BROWNS FERRY NUCLEAR PLANT, UNIT NO. 1

AMENDMENT TO FACILITY OPERATING LICENSE

Amendment No. 88
License No. DPR-33

SUPPORTING AMENDMENT NO. 88 TO FACILITY OPERATING LICENSE NO. DPR-33

Figure 3.5.K-1
MCPR LIMITS*

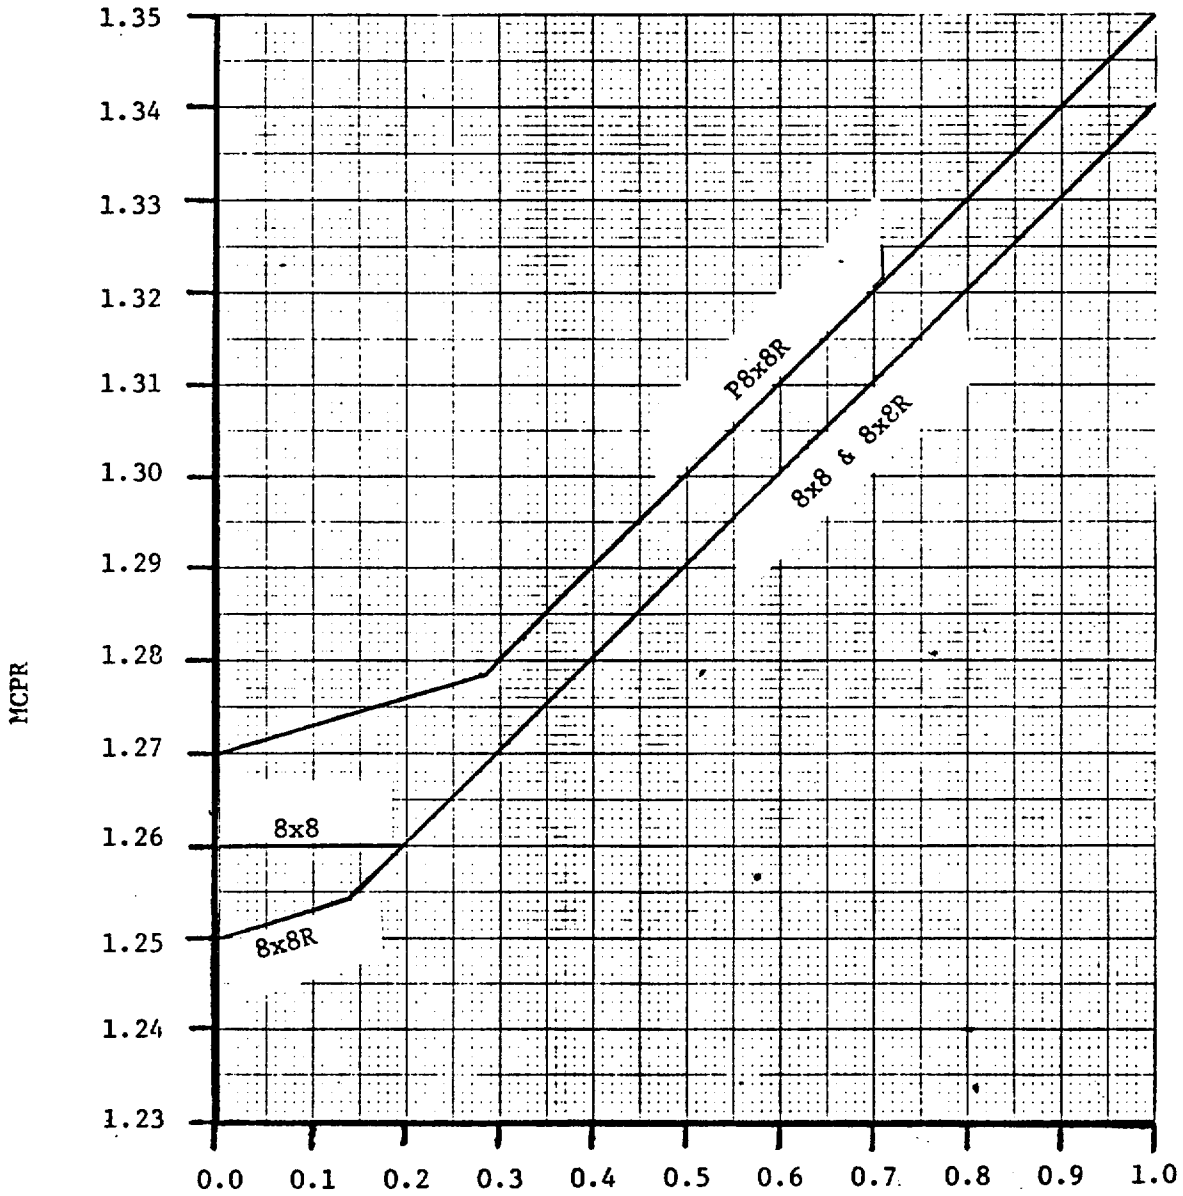
Figure 3.5.K-1 of the Technical Specifications has been modified to include the operating limit MCPR for Cycle 5 extended flow operation. Using Option A, the operating limit MCPRs shall be 1.35 for P8X8R fuel, and 1.34 for 8X8 and 8X8R fuel types. Using Option B, the operating limit MCPR shall be 1.27, 1.26 and 1.25 for P8X8R, 8X8 and 8X8R fuel types respectively. Figure 3.5.2 has been changed to include a note to reflect that the K_f factor is equal to rated core flow.
